PUBLIC HEARING MEMORANDUM

SUBJECT: **Petition #257-24**, for SPECIAL PERMIT/SITE PLAN APPROVAL to amend Special Permit #176-19 to allow for changes to the approved site plan and for additional relief to allow a garage exceeding 700 square feet, to exceed FAR and a retaining wall exceeding four feet in height

1188 Chestnut Street

ZONING REVIEW MEMORANDUM

Rear (north) Elevation

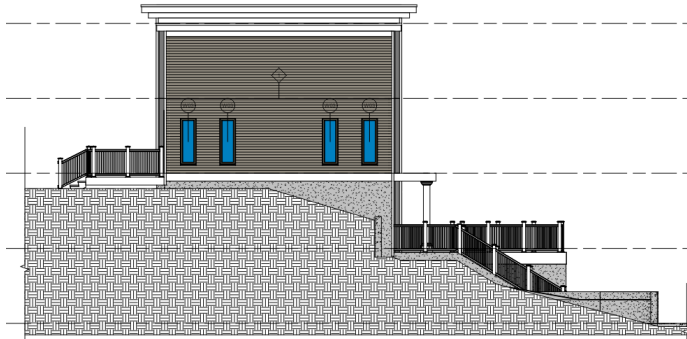
- Increase in height from approved site plan with revised roofline from 26.1 feet to 29.2 feet
- Minor changes in the approved site plan setbacks from the project resulting in slight

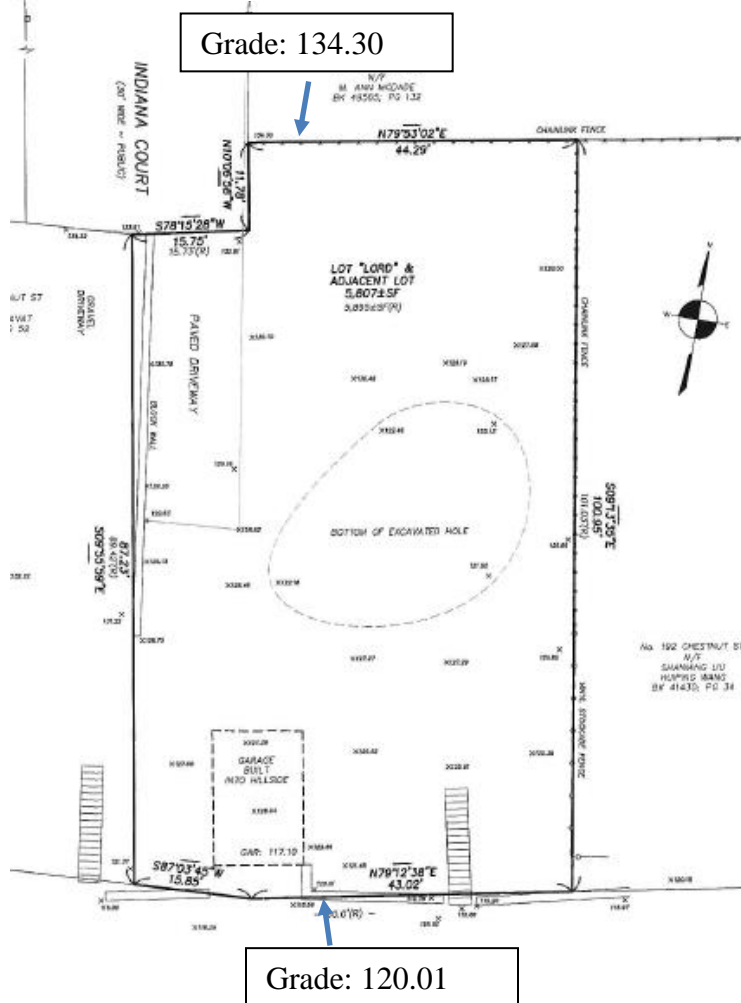
In the Planning Memo dated June 14, 2019 for the original special permit request, Planning did not support the enlarged garage from Chestnut Street because of the short setback from Chestnut Street, which could create safety issues due to limited visibility. Planning suggested the parking be located on Indiana Court. Staff also noted overgrown shrubbery on abutting properties that might hinder visibility. The petitioners have noted that they will be working with the neighbor to trim hedges on their property.
